ADDENDUM NO. CC-1

to the  
Bidding Documents

BLOOMER ELEMENTARY SCHOOL  
REMODEL  
210 S. 7<sup>th</sup> Street  
Council Bluffs, Iowa 51503  
BCDM Project No. 3103-01

## addendum

# TYPICAL GRAB BAR ELEVATIONS

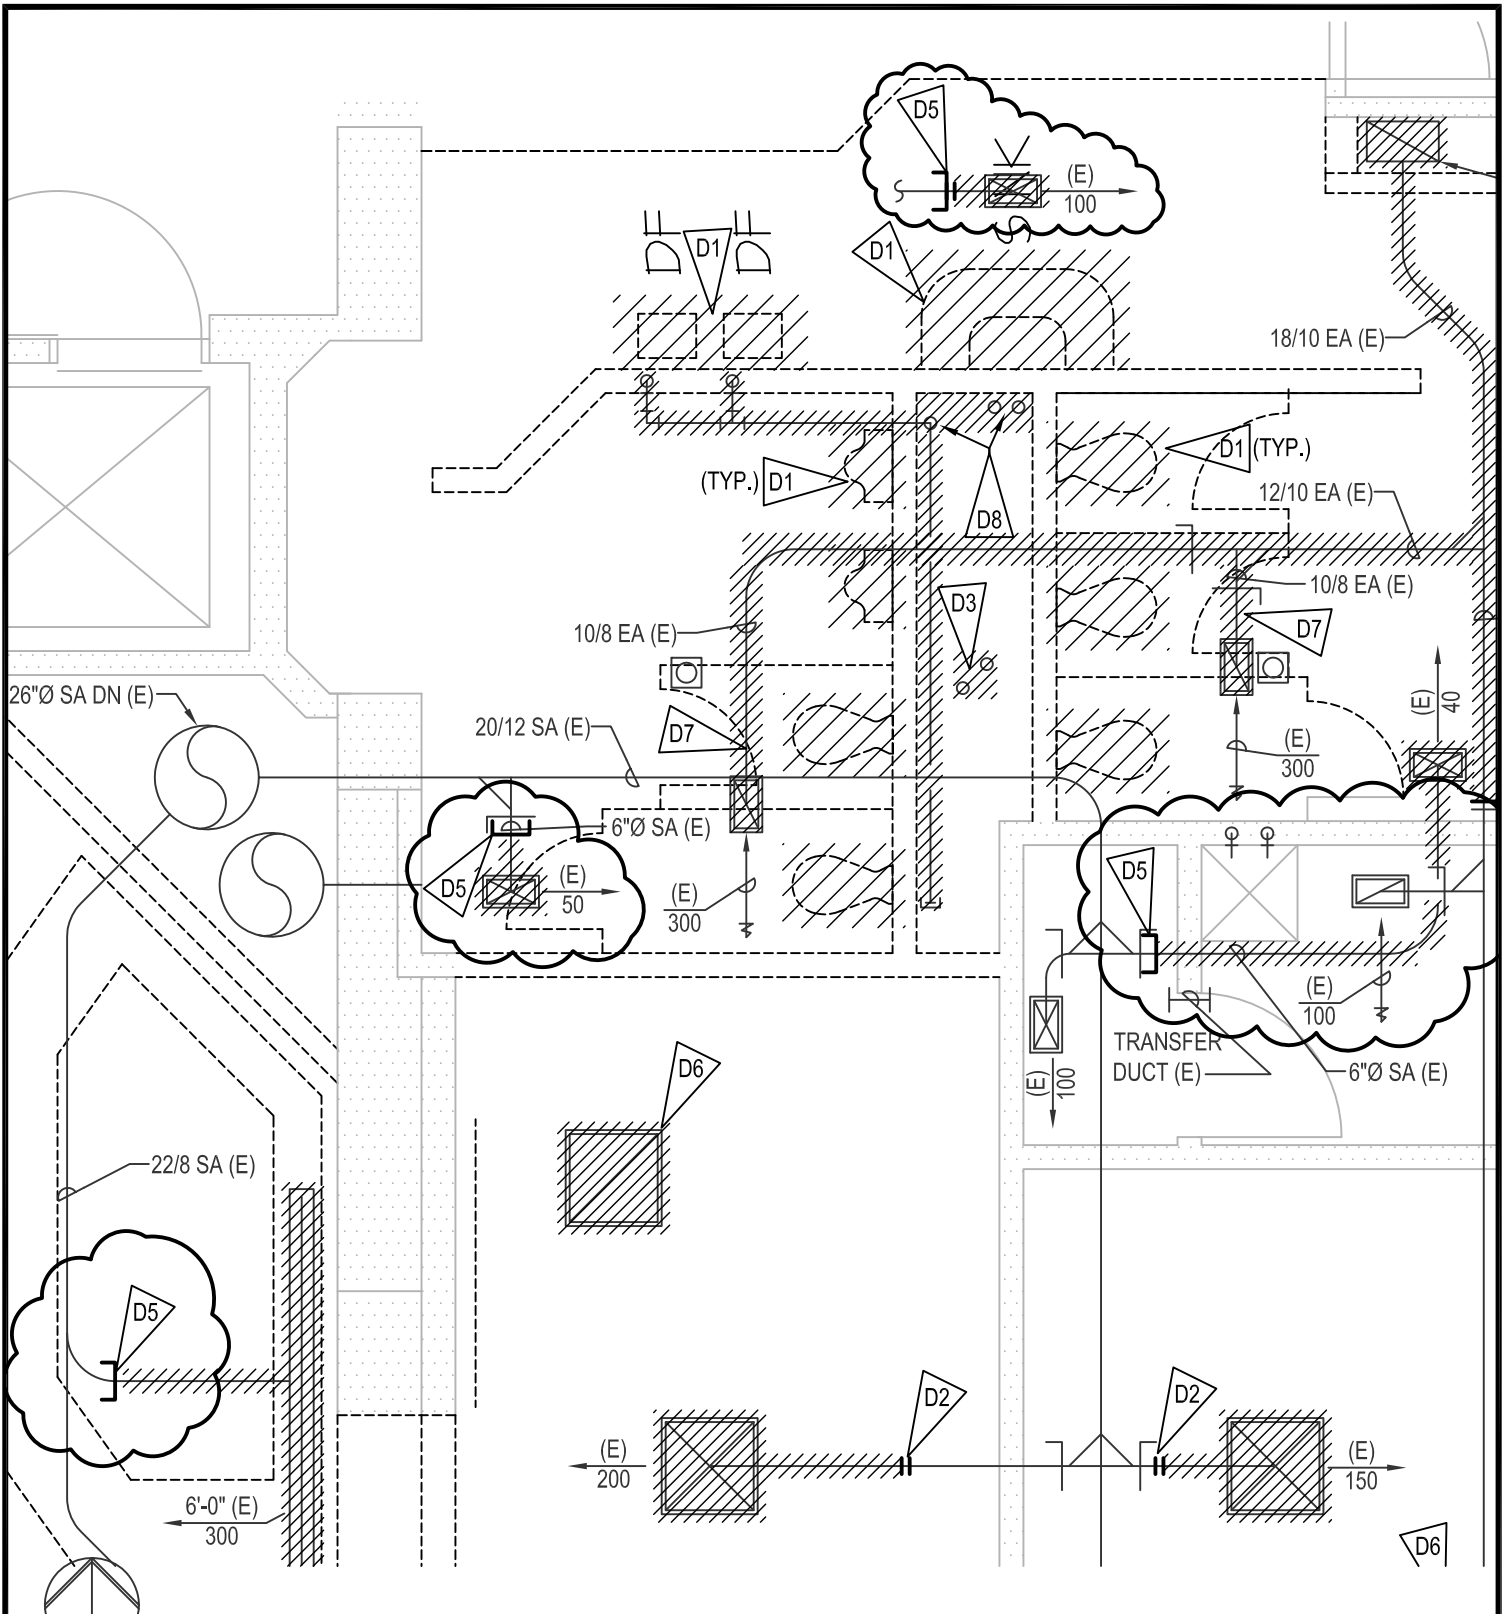
- a. At the Toilet Accessories Schedule, revise MR-1 to be "**Mirror – (24" x 36")**" and change MR-2 to be "**Mirror – (24" x 60")**".
- b. At detail 2/A1-3, add one type MR-2 mirror at the north wall of the entry to Girls 306B and one type MR-2 mirror at the south wall of the entry into Boys 306A.
- c. At detail 3/A1-3, add two type MR-2 mirrors. One each shall be located near the east and west end of the south wall of Washroom 303.
- d. Add detail 4/A1-3 per attached drawing ASD-1.

**FIRST FLOOR DEMOLITION PLAN - MECHANICAL** 1  
1/4" = 1'-0" M1-1

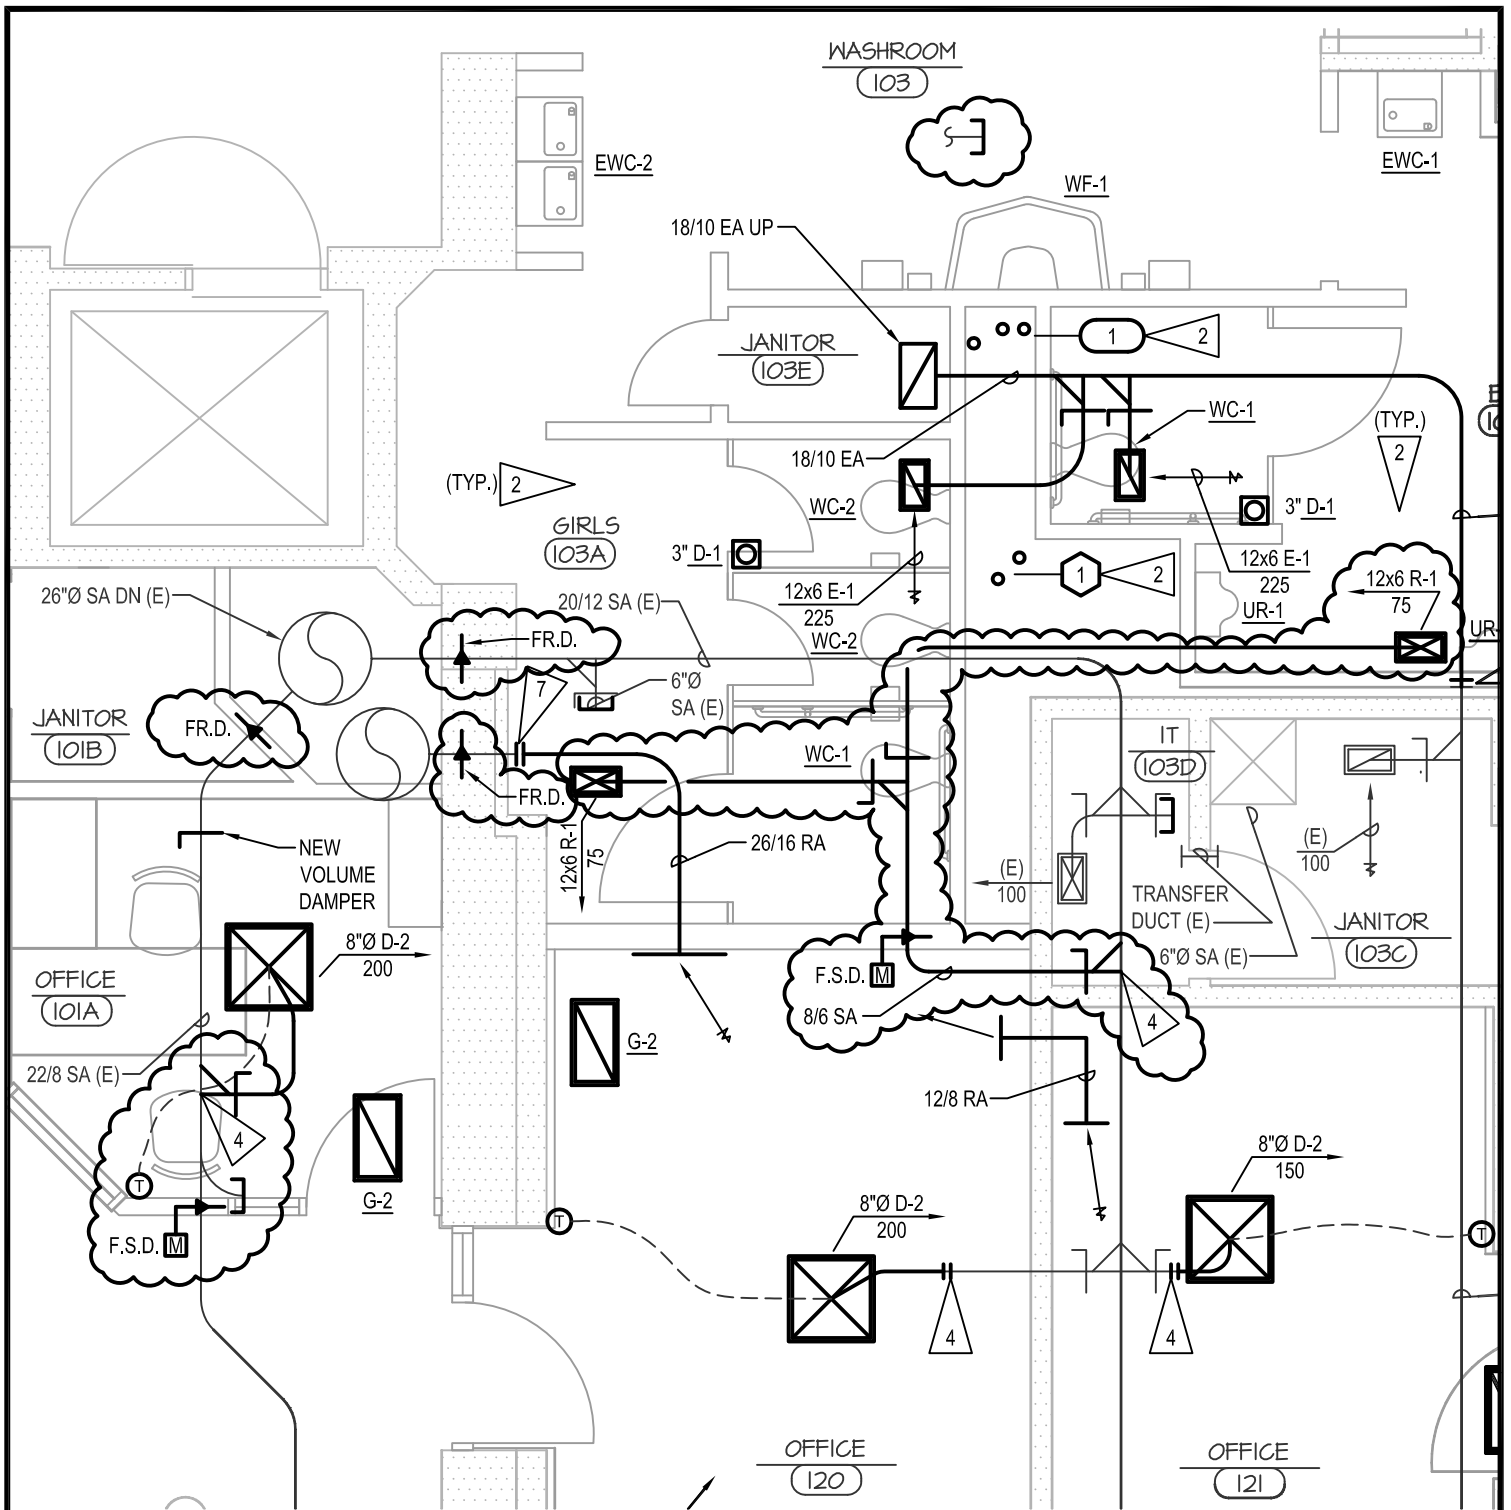
2. Sheet M1-1 First Floor – Demolition Plan, Floor Plan
  - a. See sketches M1-1a and M1-1b
3. Sheet M1-2 Second Floor – Demolition Plan, Floor Plan
  - a. Alternate Bid No 2: A.V. Work room 221A, Provide new S-1 sink, trap and stops. Reference Architectural Plans Sheet A1-2 for location.

|  |            | <p>sketch</p> <h1>M1-2a</h1> |

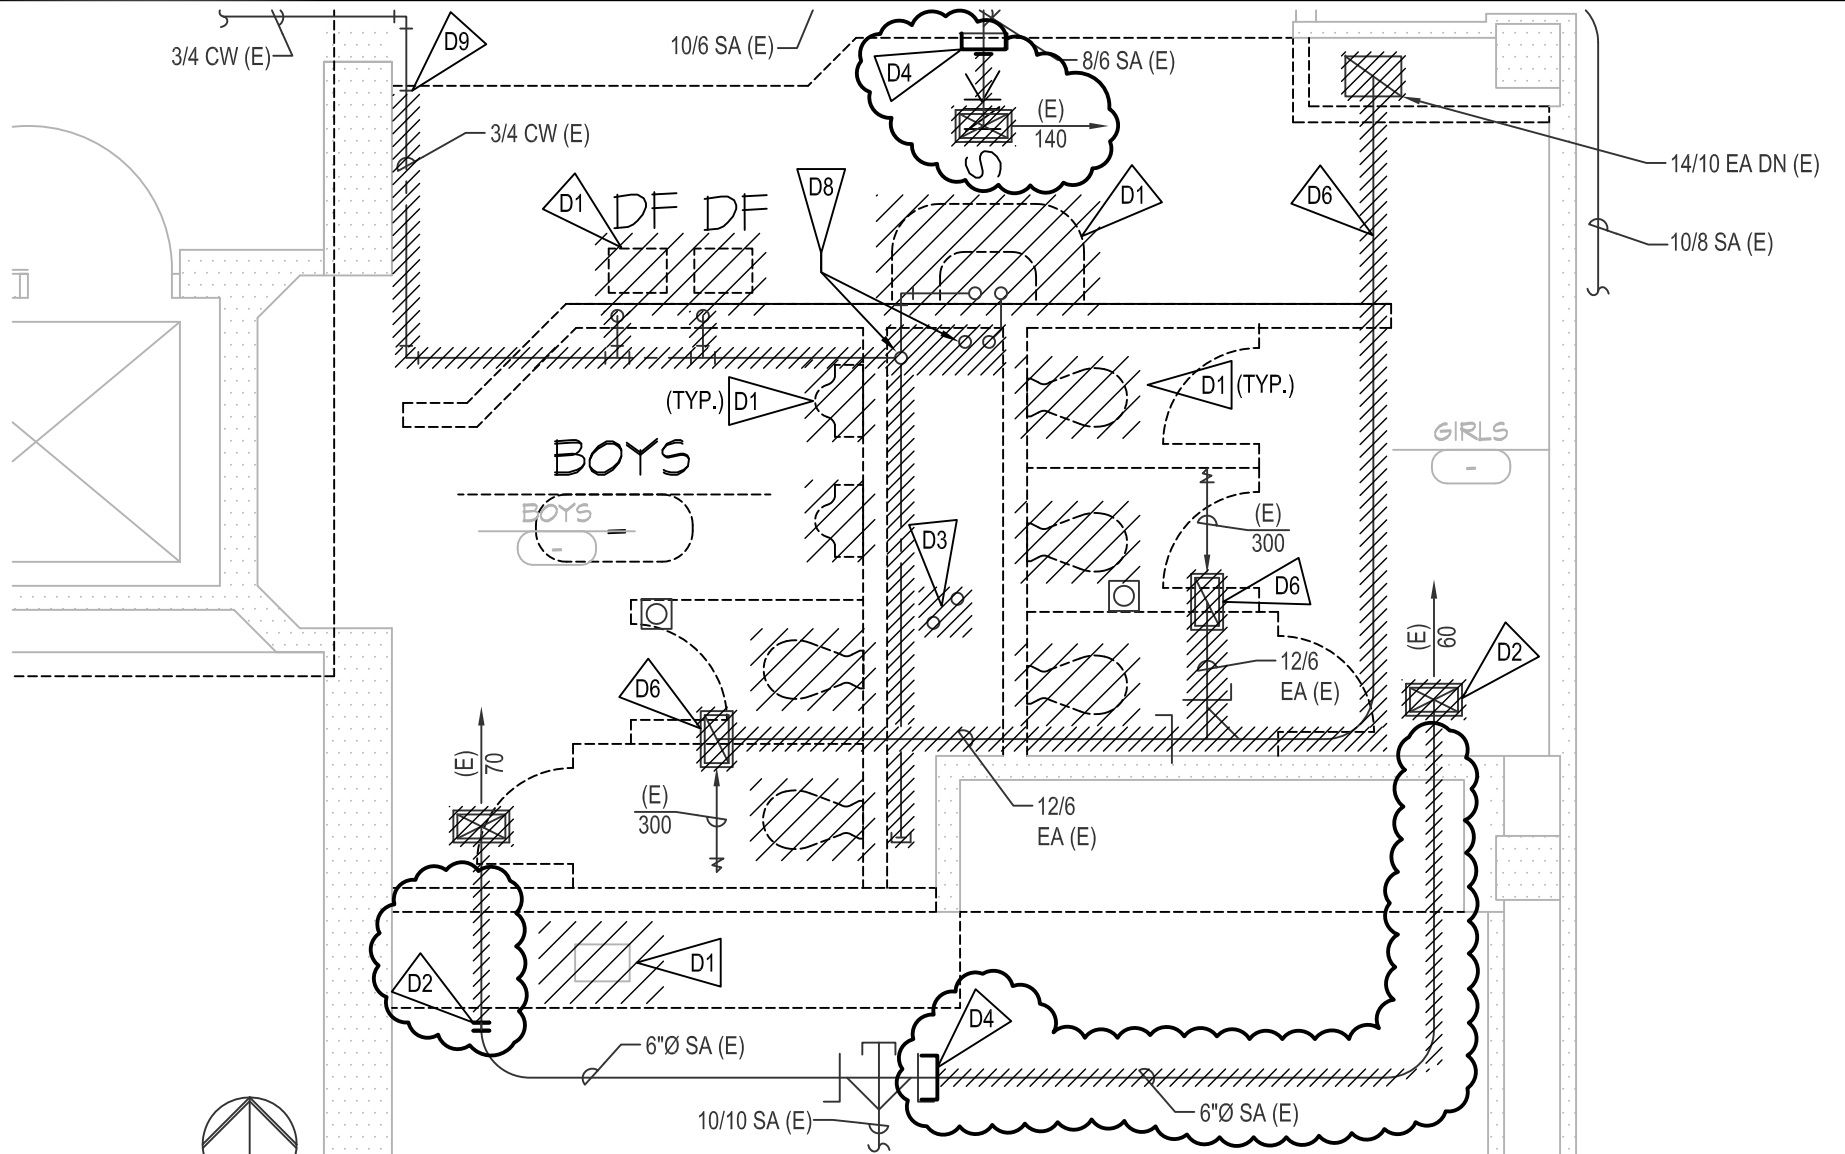
- c. See sketches M1-2a
4. Sheet M1-3 Third Floor Plan – Demolition Plan, Floor Plan
  - a. New exhaust fan EF-2.
    - i) Control of new exhaust fan shall be same as removed exhaust fan. Provide all necessary connections and wiring.

# M1-3a

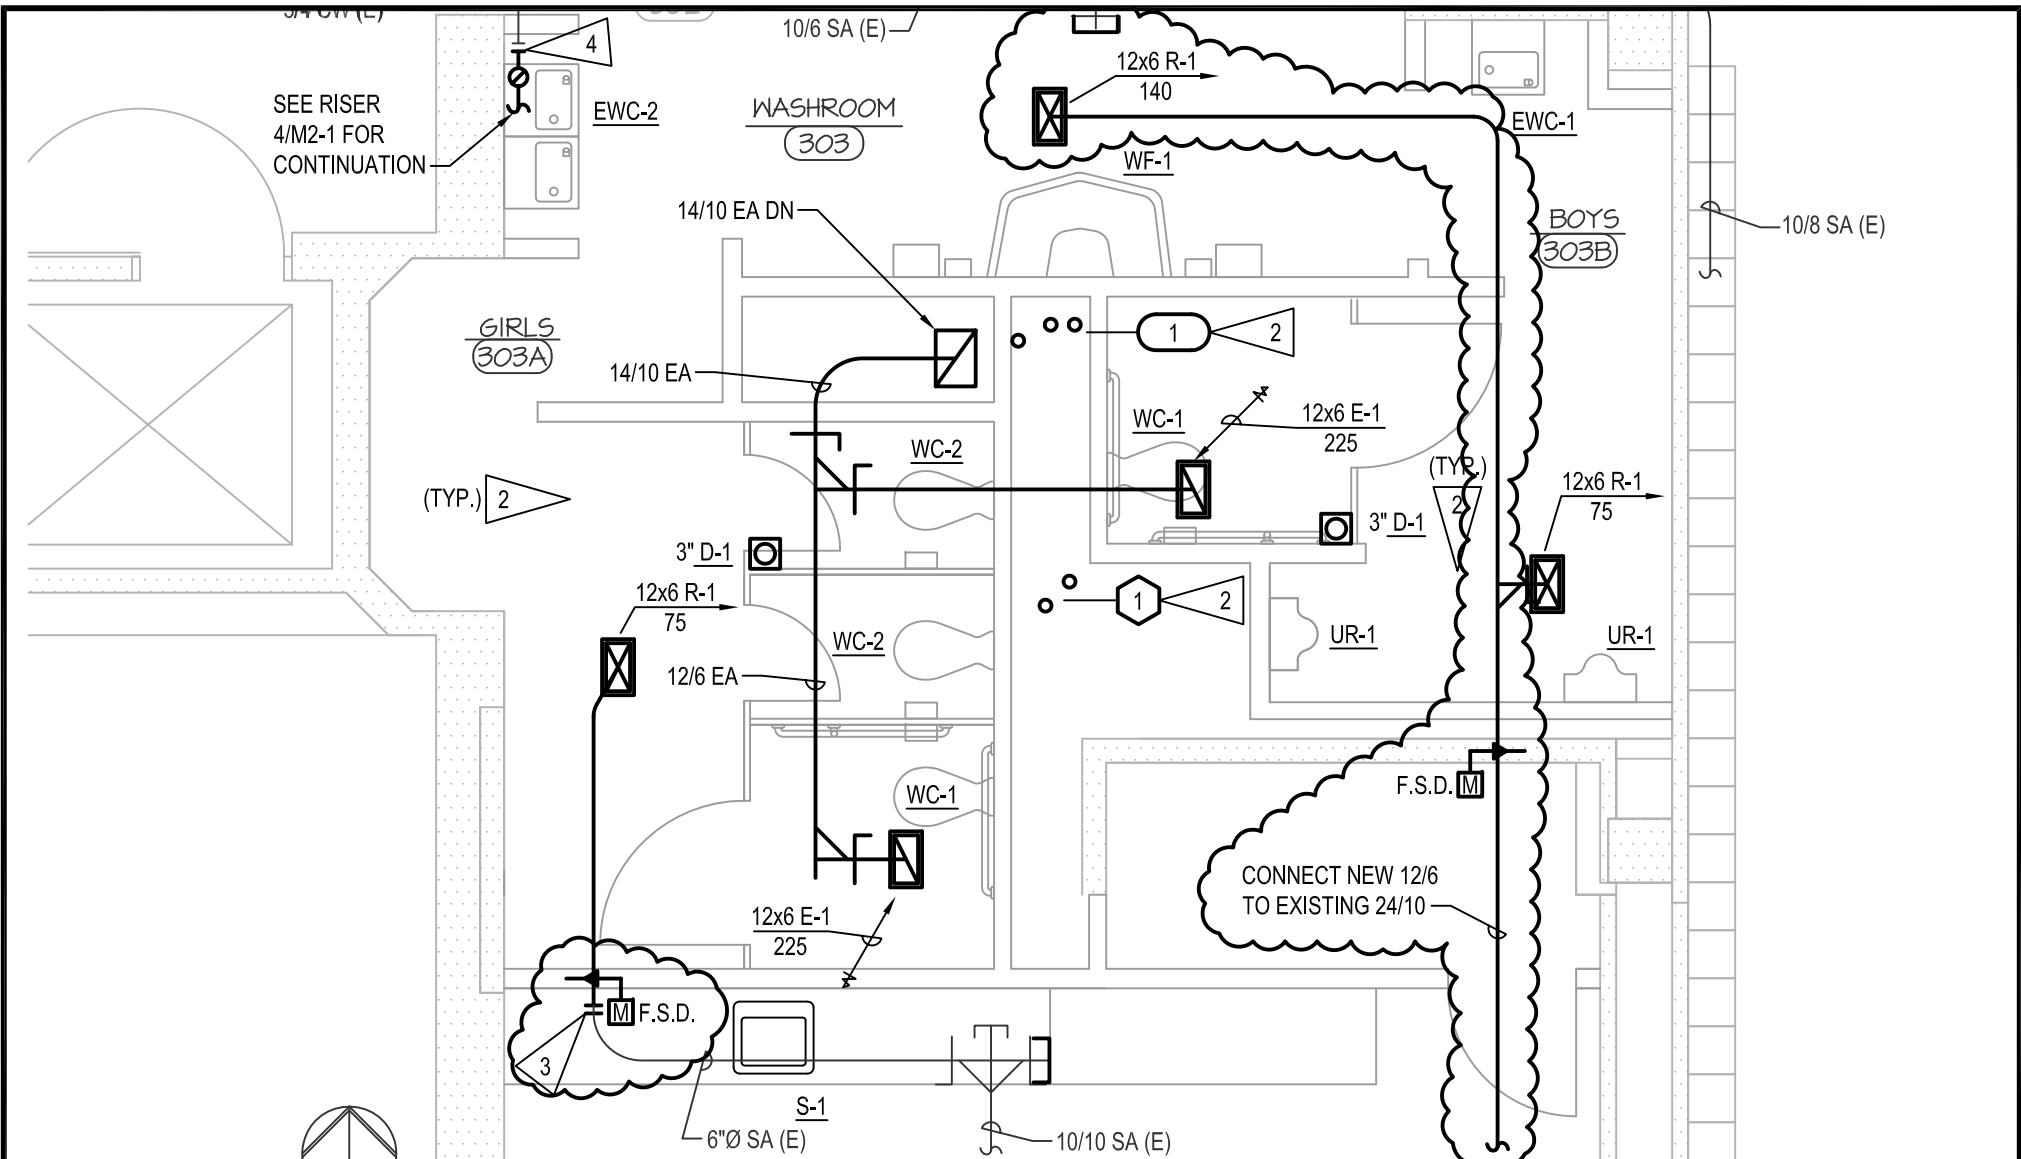
- ii) Provide roof curb adaptor for new exhaust fan.
  - b. See sketches M1-3a and M1-3b
5. Sheet M1-4 Enlarged Demolition Plans, Enlarged Floor Plans

**M1-4a**

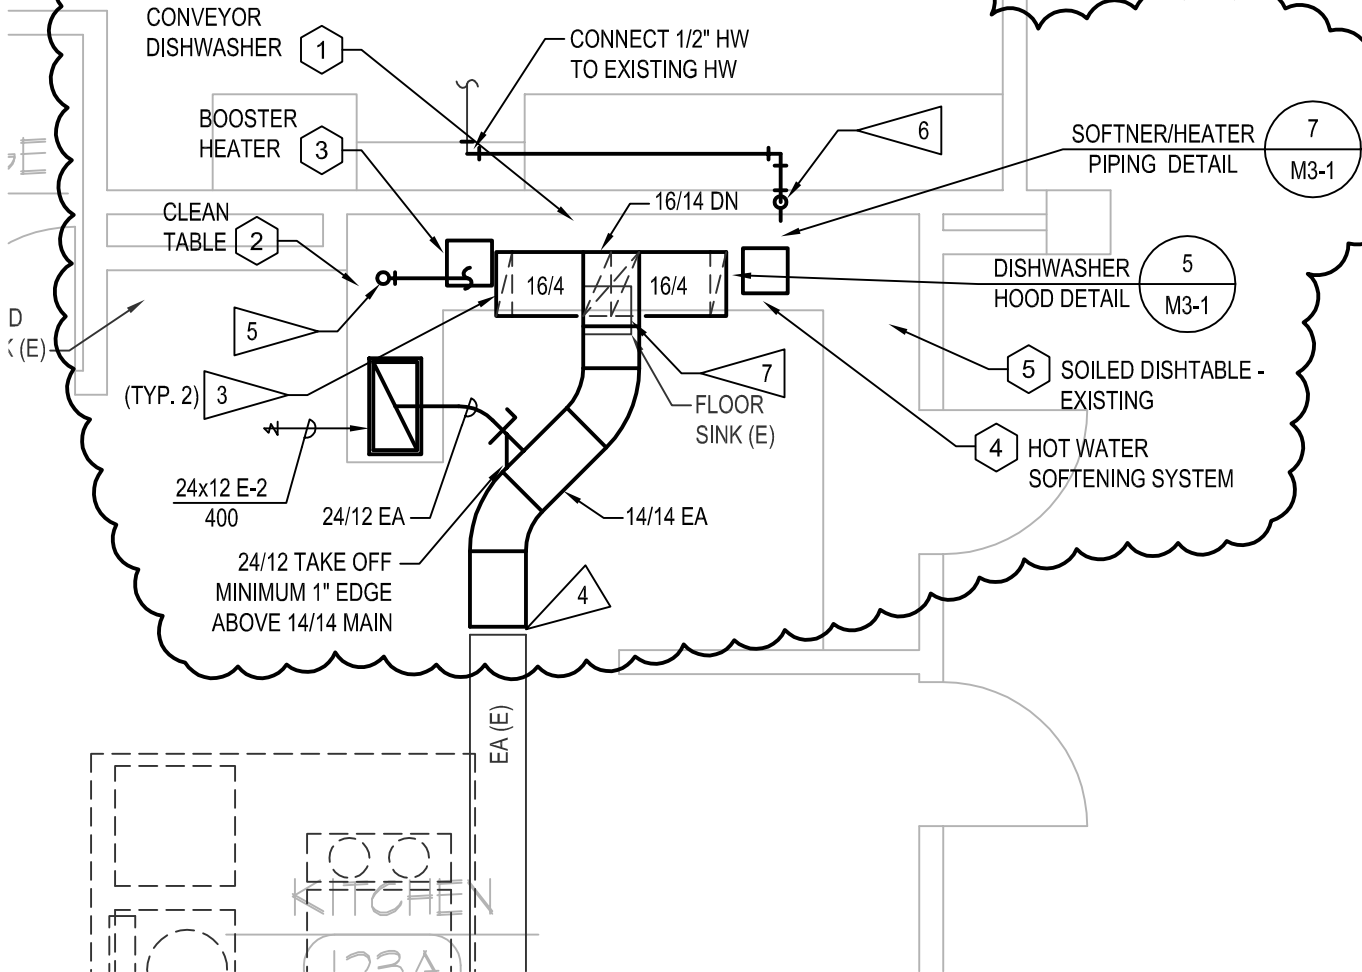
- a. Alternate Bid No 1: Provide new piping, ductwork and exhaust fan as indicated on this sheet.
  - b. See sketches M1-4a and M1-4b

- 5 1" INDIRECT DRAIN FROM ITEM (2) SHALL BE ELEVATED 4" A.F.F. AND ROUTED TO (E) FLOOR SINK BELOW DISHWASHER. SUPPORT PIPING 4" FROM FLOOR WITH STAINLESS STEEL "AVERY" DOUBLE SPLIT RING SUPPORTED FROM FLOOR. UNISTRUT NOT ALLOWED
- 6 ROUTE NEW 3/4" HW DOWN WALL TO BELOW DISHWASHER. PATCH WALL TO MATCH EXISTING AFTER PIPING HAS BEEN INSTALLED.
